# WURLITZER SERVICE SLANTS

- SUBJECT:** Model 3500-4 and 3500-7 Phonographs
- COMPLAINT:** Isolated instances of Selection Accumulator Motor running continuously when selecting LP or Preselected Program Selections, locking out Phonograph.

Figure 1.

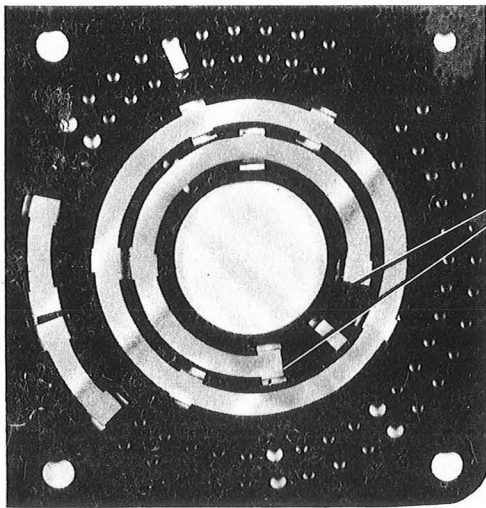
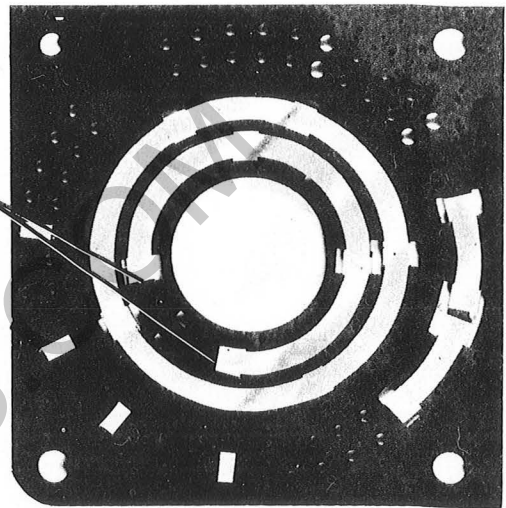
- CAUSE:** Full Cycle Patch (Contact Ring) on Cancel and/or Motor Contact Plate and Wire Assembly not correctly trimmed.
- CORRECTION:** Should the above complaint occur perform the following:

5. Examine Full Cycle Patches on both Cancel and Motor Contact Plate and Wire Assemblies and verify that both Full Cycle Patches are correctly trimmed as shown in Figure 1.

Figure 2.

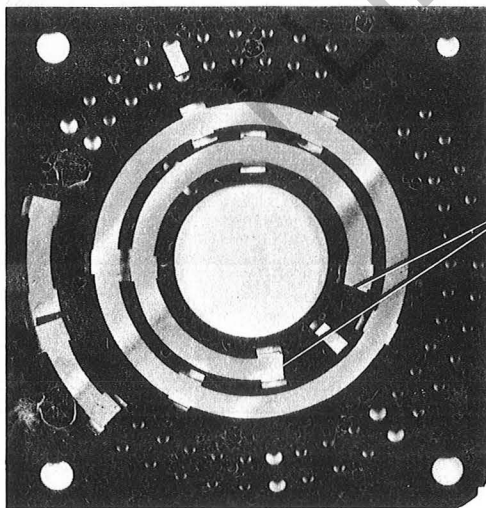
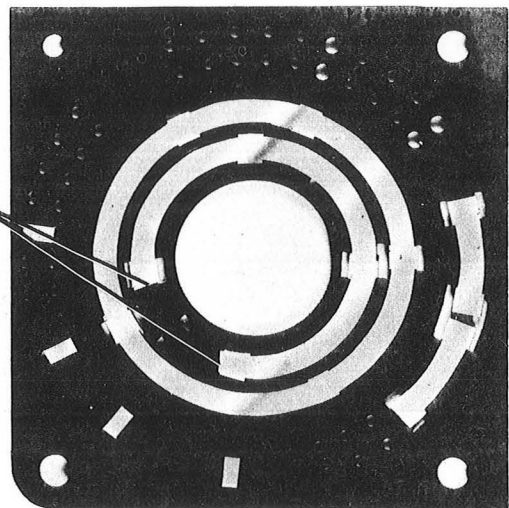
6. Should Full Cycle Patches be incorrectly trimmed, as shown in Figure 2, trim ends of Full Cycle Patches squarely with a sharp knife.
  7. Verify that no burrs remain after trimming.
